VIRGINIA ELECTRIC AND POWER COMPANY
NORTH ANNA POWER STATION UNIT 2
REVISED ASME SECTION XI RELIEF REQUESTS

**ASME Section XI Relief Requests
NDE-33, 34, and 35**

Virginia Electric & Power Company
North Anna Power Station Unit 2
Second 10 Year Interval
Request for Relief Number NDE-33

Virginia Electric & Power Company
North Anna Power Station Unit 2
Second 10 Year Interval
Request for Relief Number NDE-35

UT Scan Direction Definitions

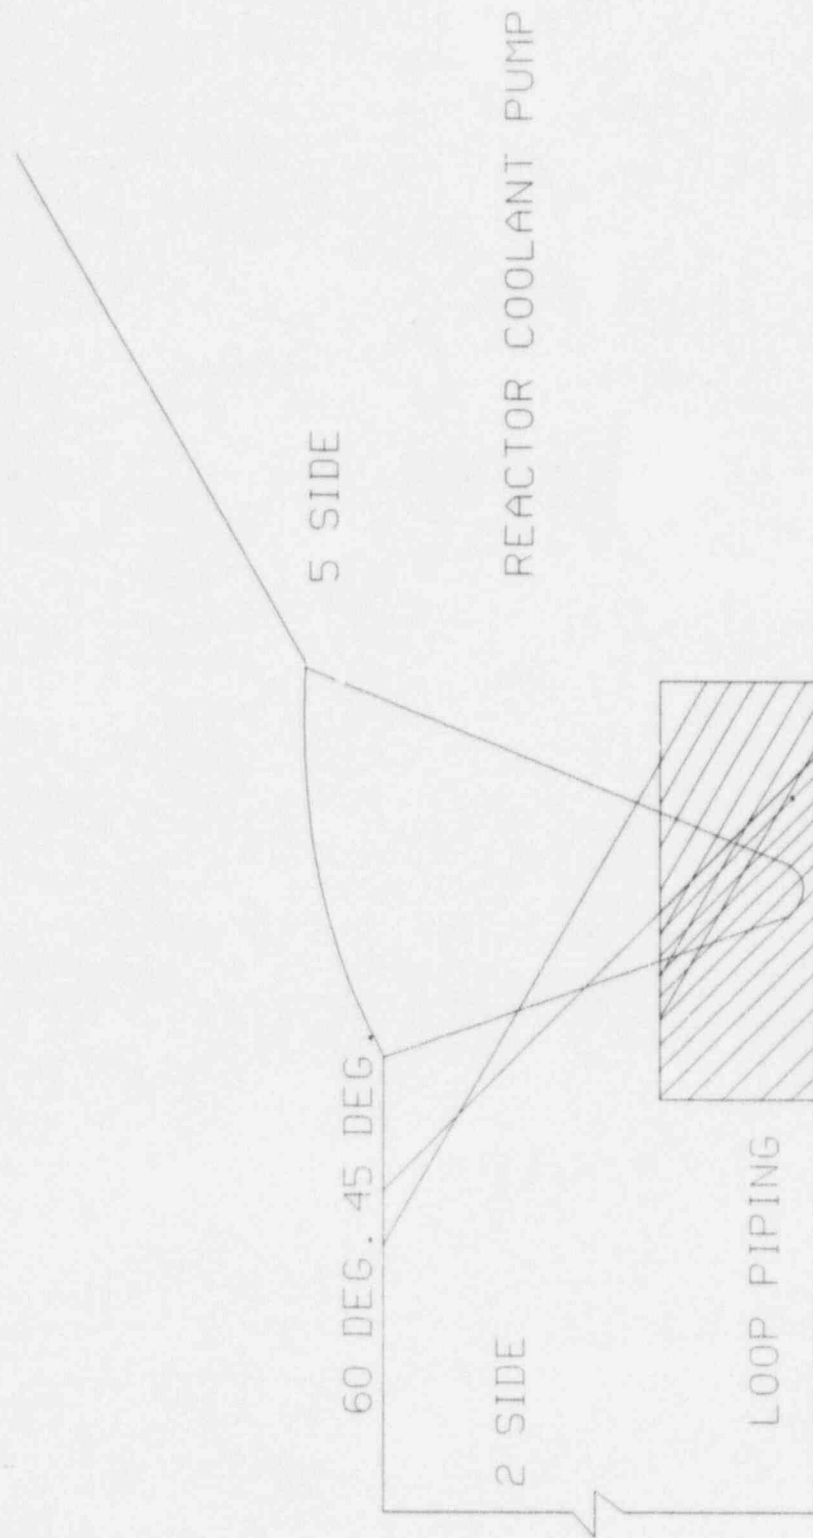
Mark/Weld#	UT Coverage %				Surface Examination % Coverage %	Reason for Partial Examination
	2	5	7	8		
9	97	0	50	50	100	Nozzle and weld joint configuration and material type (ASTM A-351 austenitic steel casting) limit the use of an extended V-path examination. The weld was examined to the maximum extent practical using 45° and 60° RTD search units from the loop pipe side. Approximately 97% of the lower 1/3 of the weld was covered in the 2 direction.
20	0	100	100	100	100	Nozzle and weld joint configuration and material type (ASTM A-351 austenitic steel casting) limit the use of an extended V-path examination. The weld was examined to the maximum extent practical using 45° and 60° RTD search units from the loop pipe side. Approximately 100% of the lower 1/3 of the weld was covered in the 5 direction.

It is proposed that the examinations already completed at the reduced coverage be counted as meeting the Code requirements. In addition:

1. A visual (VT-2) examination will be performed during the normally scheduled system leakage test each refueling outage;
2. Technical Specifications requires that the reactor coolant system leak rate be limited to one gallon per minute unidentified leakage. This value is calculated at least once per 72 hours; and
3. The containment atmosphere particulate radioactivity is monitored every 12 hours.

WELD 9
Figure NDE-33-1

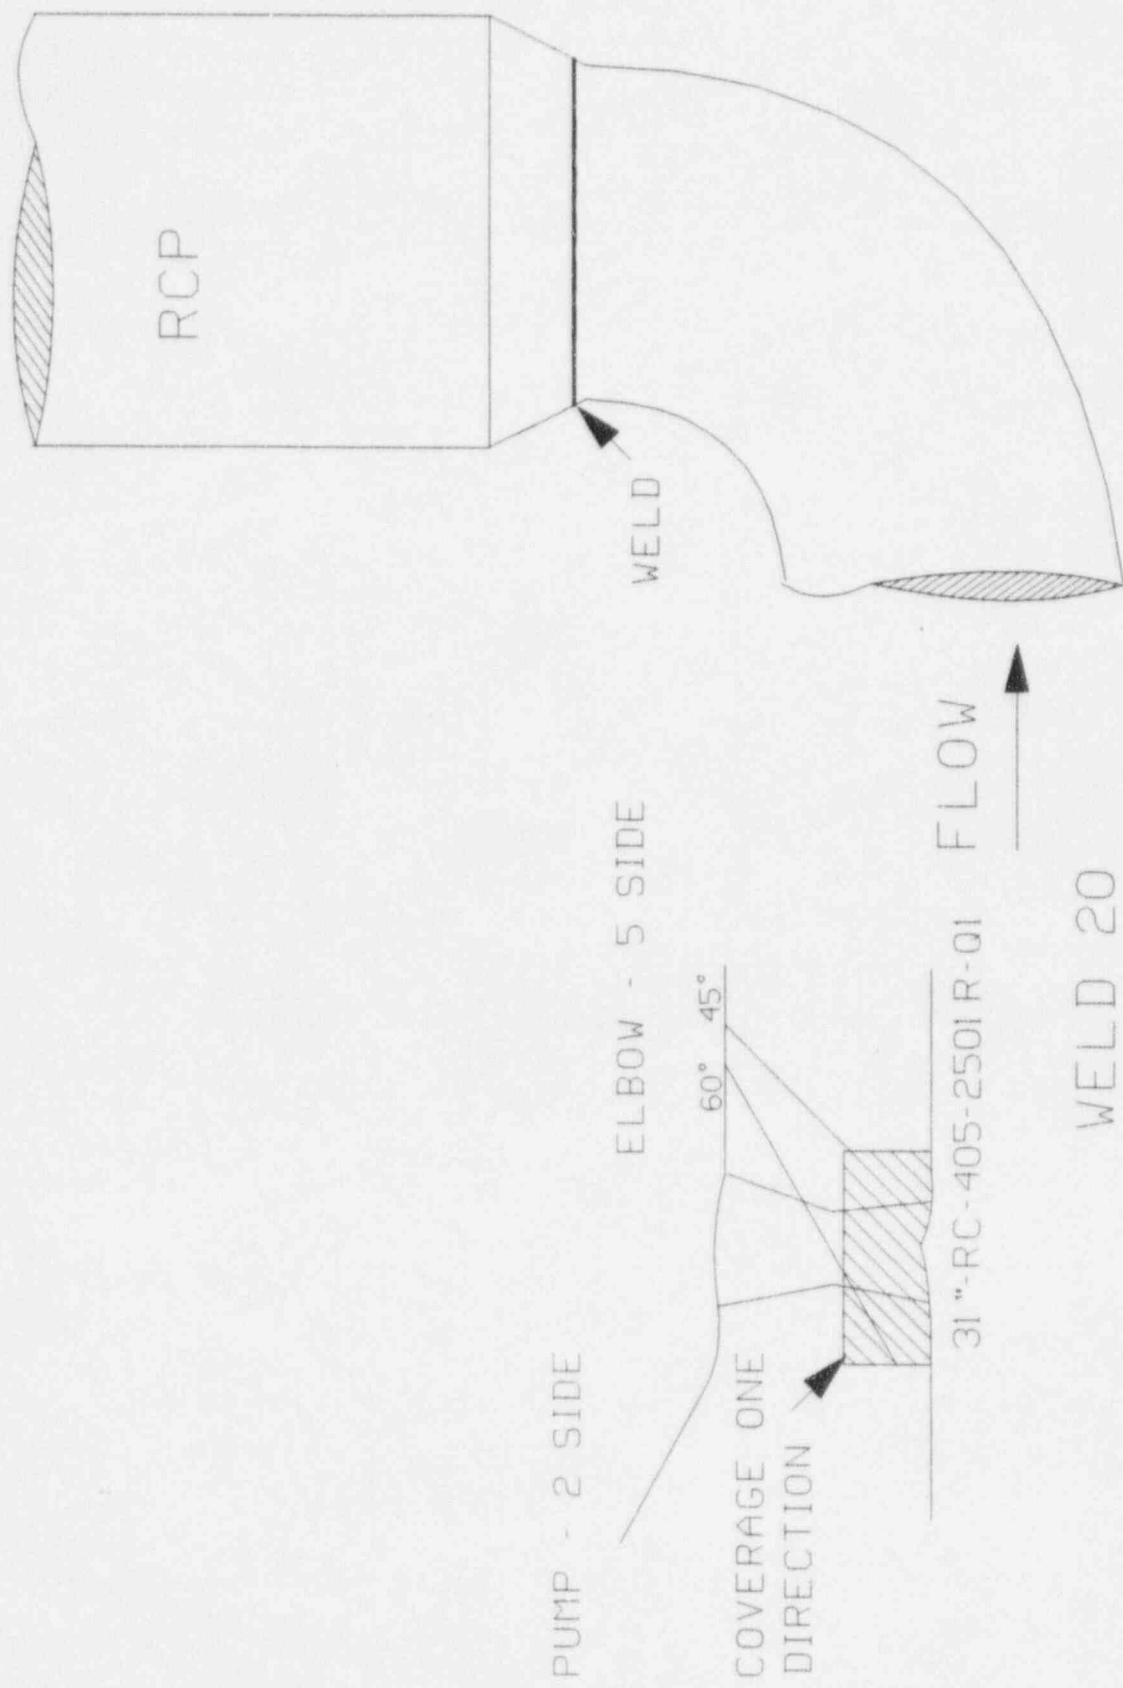
The components listed above have been examined to the extent practical as required by the Code. The Code required volumetric examination coverage was reduced due to weld joint geometry, and the material type from which the components are constructed. The scope of volumetric examination coverage completed for the above listed welds is listed in Table NDE-33-1. Figures NDE-33-1 and NDE-33-2 are provided detailing the limitations experienced. These welds are classified as terminal ends and are required to be examined by the ISI Program.

Figure NDE-35-1

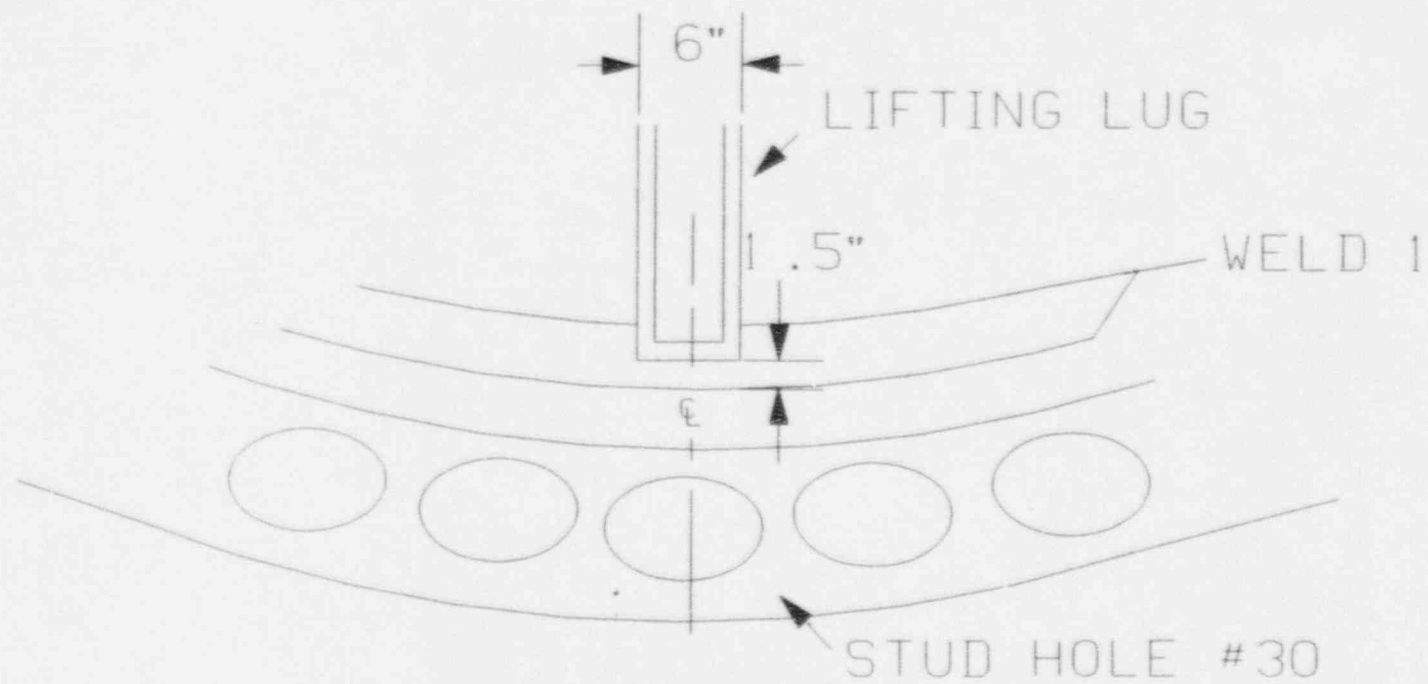
The component listed above has been examined to the extent practical as required by the Code. Due to the joint configuration and a lifting lug the required volume could not be examined. The reduction in coverage is detailed in Table NDE-35-1. Figures NDE-35-1 and NDE-35-2 are provided detailing the limitations experienced.

Mark/Weld#	Beam Angle	Exam Area	Scan Direction	% Exam	Reason For Partial
1 (120° - 240°)	0	Weld & Base	-	96	Joint configuration and material type (ASTM SA-533 GR. B with stainless steel cladding) limit the use of an V-path examination. Lift lug restricts UT scans in all directions.
	45	Weld	2	48	
	45	Weld	5	96	
	45	Weld	7	95	
	45	Weld	8	95	
	60	Weld	2	15	
	60	Weld	5	96	
	60	Weld	7	95	
	60	Weld	8	95	
	45 & 60	Base	2	56	
	45 & 60	Base	5	96	
	45 & 60	Base	7	95	
	45 & 60	Base	8	95

It is proposed that the examinations already completed at the reduced coverage be counted as meeting the Code requirements. In addition:

1. A visual (VT-2) examination will be performed during the normally scheduled system leakage test each refueling outage;
2. Technical Specifications requires that the reactor coolant system leak rate be limited to one gallon per minute unidentified leakage. This value is calculated at least once per 72 hours; and
3. The containment atmosphere particulate radioactivity is monitored every 12 hours.
